Field campaign

Topic	Tailgate hinge bolt (SC18/14)
Market area	Bentley: worldwide (2WBE),Hongkong-Macau (5HK)
Brand	Bentley
Transaction No.	2052498/2
Campaign number	EB11
Note	
Type	
US code

Bentayga

Figure 1

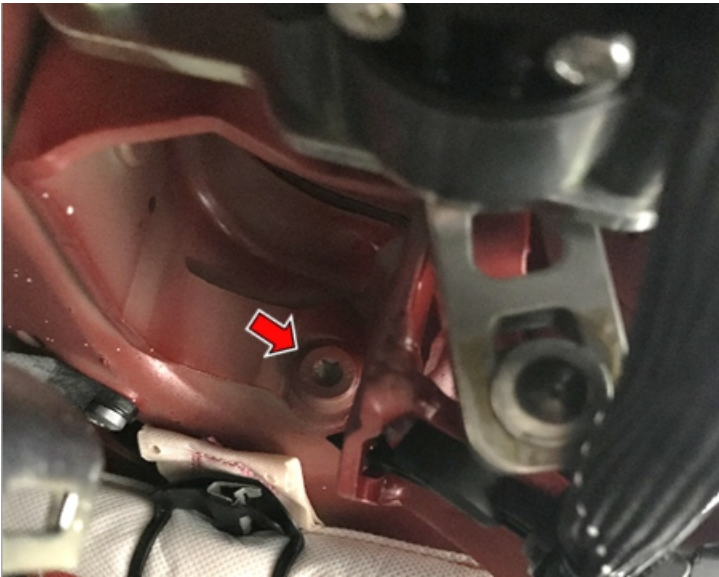
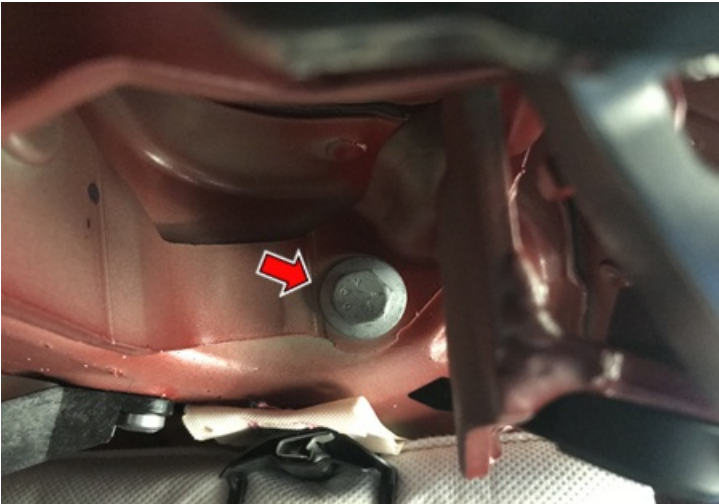
Replace the highlighted old bolt (*Figure 1*) with the highlighted new bolt **N 107 884 01** (*Figure 2*) on **both** tailgate hinges

Tightening torque for new bolt:

20 Nm + 90°

The bolt must be tightened to 20Nm + 90° and no more

The bolt must be replaced if re-torque is required

Figure 3

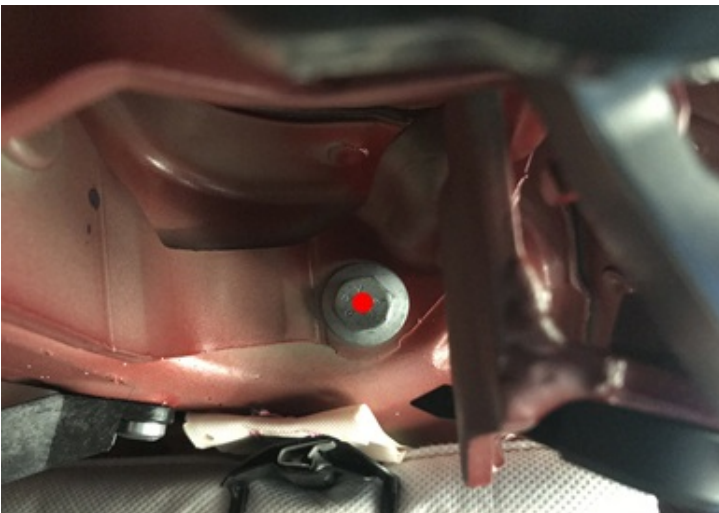
On completion apply a RED paint mark to each of the new bolts (Figure 3). The presence of the RED paint mark confirms campaign completion
